Final Product/Process Change Notification

Document # : FPCN22500Z

Title of Change:	D2PAK Case Outline Standardization from 418B-04 to 418AJ for all effected devices manufactured in On Semiconductor Seremban, On Semiconductor Vietnam and TFME facility.	
Proposed Changed Material First Ship Date:	14 June 2020 or earlier upon customer approval	
Current Material Last Order Date:	NA Orders received after the Current Material Last Order Date expiration are to be considered as orders for new changed material as described in this PCN. Orders for current (unchanged) material after this date will be per mutual agreement and current material inventory availability.	
Current Material Last Delivery Date:	NA The Current Material Last Delivery Date may be subject to change based on build and depletion of the current (unchanged) material inventory.	
Product Category:	Active components – Discrete components	
Contact information:	Contact your local ON Semiconductor Sales Office or <Norsahida.sahman@onsemi.com>

D²PAK 3
CASE 418B-04
ISSUE L

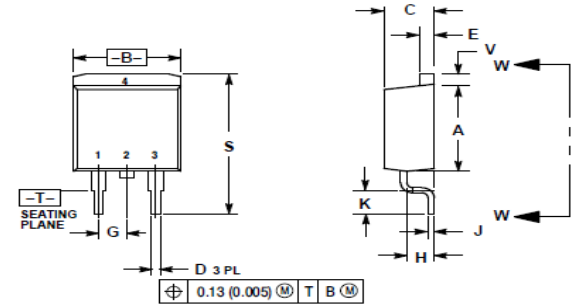
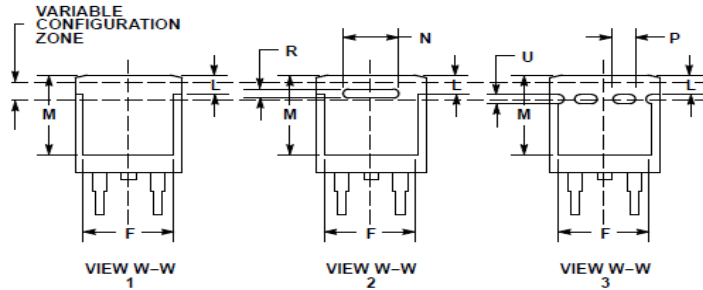
Change Category	Type of Change	
Data Sheet	Change of datasheet parameters/electrical specification (min./max./typ. values) and/or AC/DC specification	
Description and Purpose:		
<p>ON Semiconductor is migrating the D2PAK discrete package case outline from version 418B-04 to version 418AJ. The change impacts the Rectifier, BJT and MOSFET product lines. This transition allows ON Semiconductor to standardize its significantly increased portfolio on a single case outline.</p> <p>This notification does not represent a change to existing materials, tools or processes used to manufacture the affected devices. The new case outline, 418AJ, is consistent with JEDEC dimensional guidelines for the D2PAK.</p> <p>There are no product material changes as a result of this change.</p> <p>There is no product marking change as a result of this change.</p>		
	Before Change Description	After Change Description
Case Outline	418B-04	418AJ

OLD CASE OUTLINE:

D²PAK-3 (TO-263, 3-LEAD)
CASE 418AJ
ISSUE C

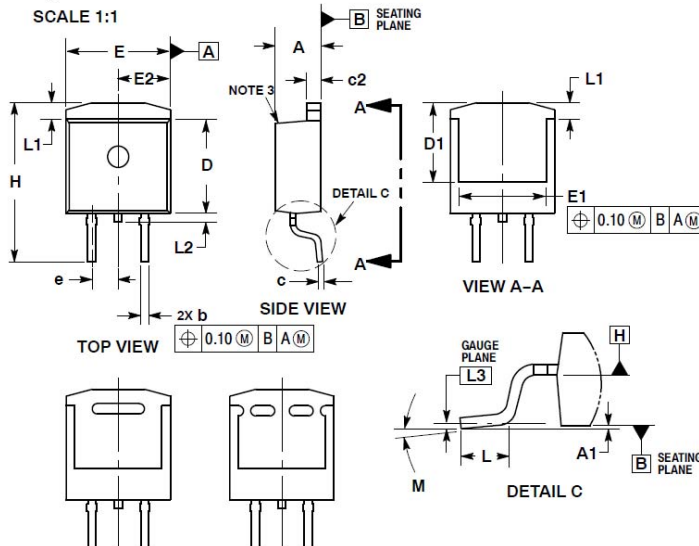
NEW CASE OUTLINE:

D²PAK 3
CASE 418B-04
ISSUE L

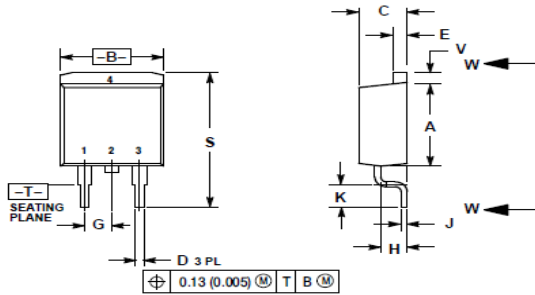
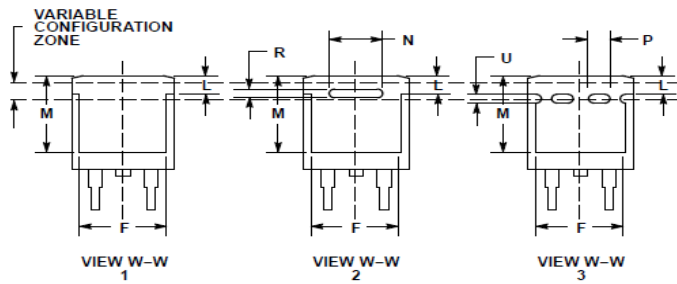
変更カテゴリ:	変更種別	
データシート	データシートパラメータ/電気的特性規格 (最小/最大/通常値) および/または AC/DC 規格の変更	
説明および目的:		
<p>オン・セミコンダクターは、D2PAK ディスクリートパッケージのケースアウトラインを、バージョン 418B-04 からバージョン 418AJ に移行します。この変更は、整流器、BJT、および MOSFET 製造ラインに影響を与えます。この移行により、オン・セミコンダクターは大幅に増大したポートフォリオを単一のケースアウトラインに標準化できます。</p> <p>この通知は、対象製品の製造に使用される既存の材料、ツール、またはプロセスへの変更を意味するものではありません。新しいケースアウトラインの 418AJ は、D2PAK の JEDEC 寸法ガイドラインに適合しています。</p> <p>今回の変更に伴う製品材料の変更はありません。</p> <p>今回の変更に伴う製品マーキングの変更はありません。</p>		
	変更前の表記	変更後の表記
ケースアウトライン	418B-04	418AJ

旧ケースアウトライン:

D²PAK-3 (TO-263, 3-LEAD)
CASE 418AJ
ISSUE C

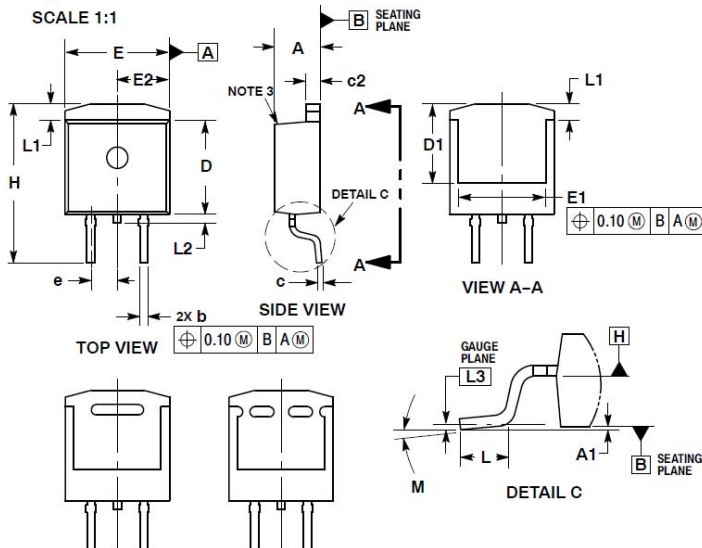
新ケースアウトライン:
